Study for beam stopper location change on LNE 02

- Proposal from TE/VSC
 - New layout

Original Layout

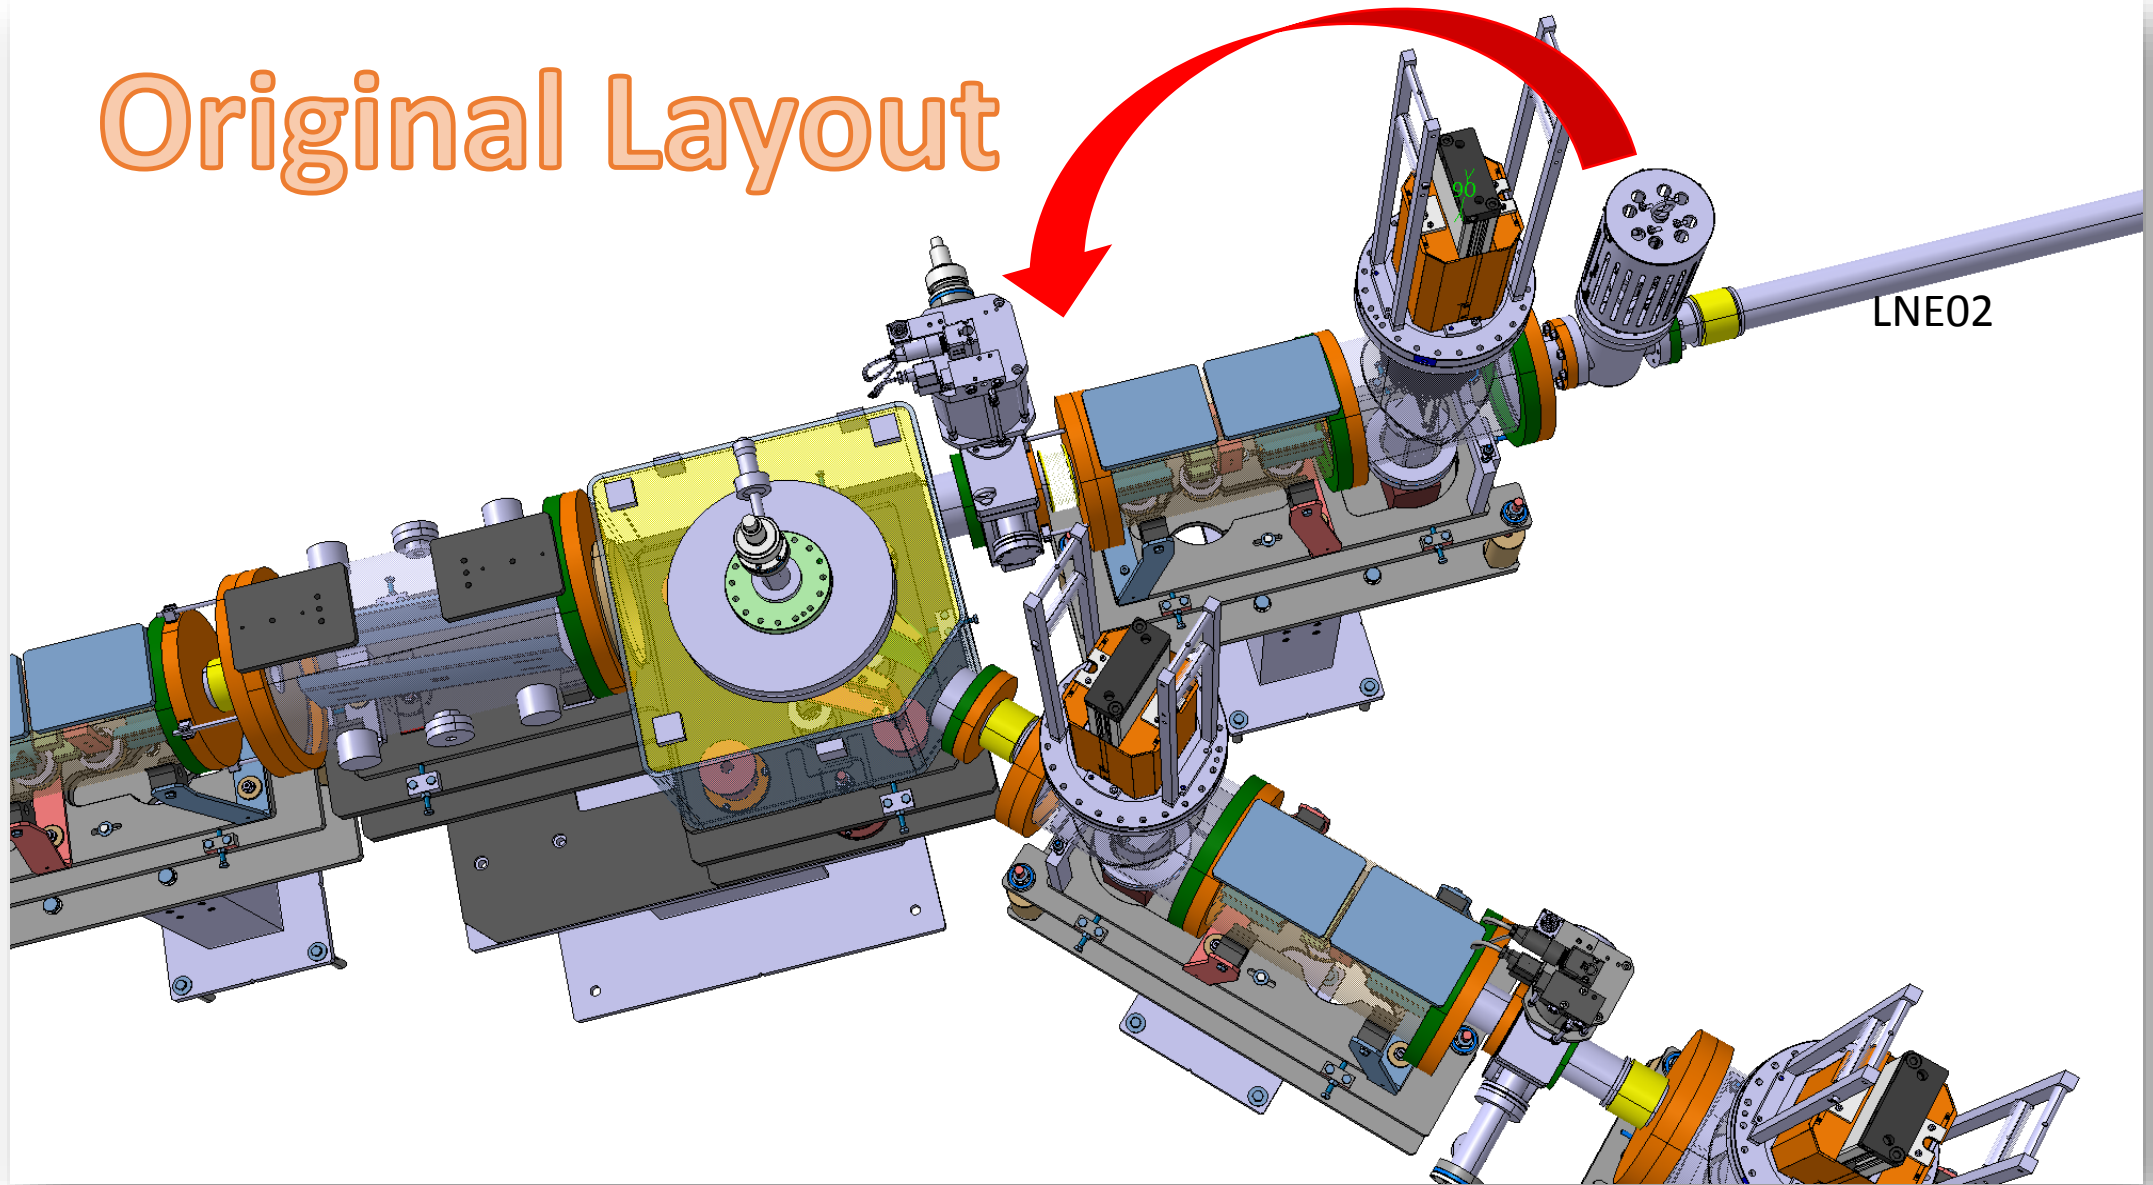
- Reduce transition length (168.5 to 83 mm) for CF100-63 with the space allocated
 - It changes the ID from 63 to 46 mm with a new bellows design
 - Vacuum chamber through the wall modified (1455 to 1430 mm)
 - Is it compatible with optics in this region?
 - Delivery time for specific bellows takes 3 months for production
- Proposal from TE/ABT
 - New layout with different ZQNA-SEM location
